Subject: RE: Asking your approval for vault hatch with grating in Pioneer Sq Preservation Dist, SCL Network Distribution

ADDRESSES WHY SCL WILL REPLACE THE SOLID HATCH, AND REPLACE IT WITH THE GRATING, FOR VAULT 022V004 AT 117 S MAIN STREET, PIONEER SQUARE

LETTER RESPONDING TO PIONEER SQUARE PRESERVATION BOARD JULY 7TH, 2023 CORRECTION NOTICE PSB 185/23

Hatch to be replaced
with grating

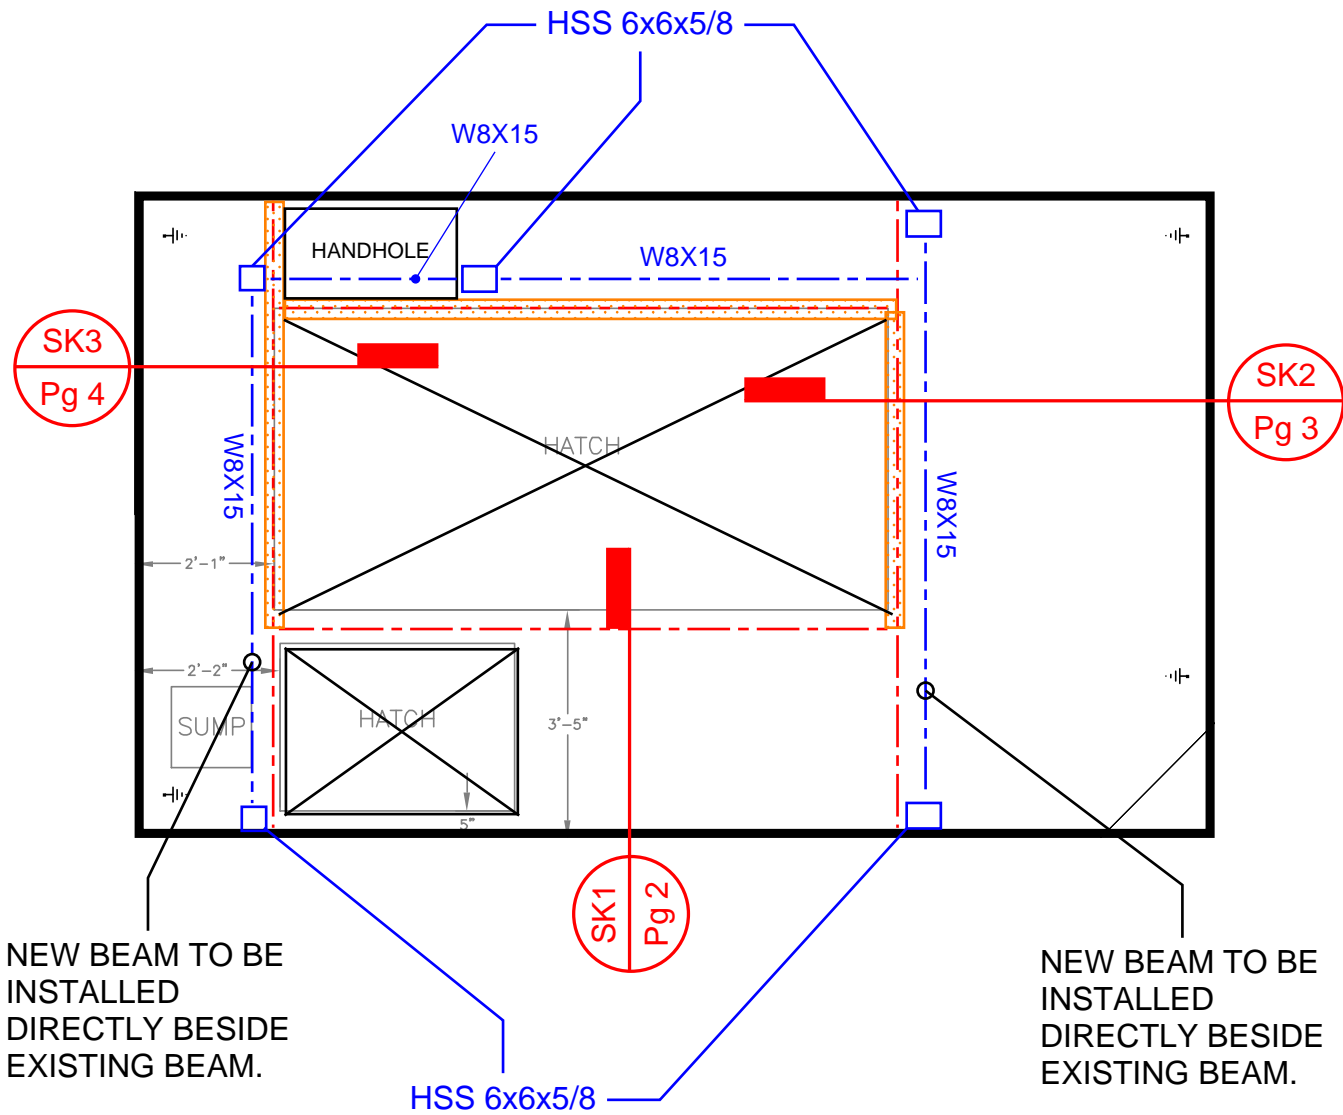
The “hatch” you point to actually appears to a panel of historic glass prism lights. Add to your application a closer photo of the prism lights. I would suggest that you try to find an alternative for the grating that does not require the demolition of historic materials such as installing the grating in another location so the glass prism light panel can remain in place. Any proposal to remove them needs to include a detail survey of the condition of the prism light condition and alternatives explored to avoid the demolition of the prism lights and a thorough explanation as to why this even needs to be done and done at this particular location and being there is already a grated area in the sidewalk why that is not enough venting.

- 1) The hatch SCL Network to replace appears to a panel of historic glass prism lights. Department of Neighborhood suggested SCL Network Engineering to find an alternative for the grating that does not require the demolition of historic materials such as installing the grating in another location so the glass prism light panel can remain in place.

- 2) Department of Neighborhood also asked that proposal to remove them needs to include a survey of the condition of the prism light condition and alternatives explored to avoid the demolition of the prism lights and an explanation as to why this needs to be done and done at this particular location and being there is already a grated area in the sidewalk why that is not enough venting.

If the hatch can't be opened, the vault loses its functionality, because the equipment needs to be got in and out through the rectangular opening. Right now, the hatch is rusted into the surrounding frame, the only way to open is to demolish this solid hatch by breaking it up into pieces.

Currently customer in 200 1st Ave South is expanding, the indoor electrical vault must be modified. The expansion requires larger and more reliable electrical service. To accommodate their electrical needs, and being requested by the customer, the existing transformer must be relocated to the nearest vault to provide the same electrical service to the nearby business. Vault 022V004 is the only vault that transformer can move to and meet the service requirement. To accommodate the relocated transformer, grating hatch is needed, to increase the airflow thus maintaining the operable temperature inside the vault 022V004. As Department of Neighborhood has noticed, there is a grating cover next to the rectangular hatch, but it's too small to provide the air circulation for the transformer cooling.

- a. Almost all Glass Prism Lights on this vault hatch have been chipped off and left sizable holes. It no longer shows any historical value or visual appealing anymore.

- b. All electrical vaults in the area have grating for hatches, it's been the standard in the vicinity.
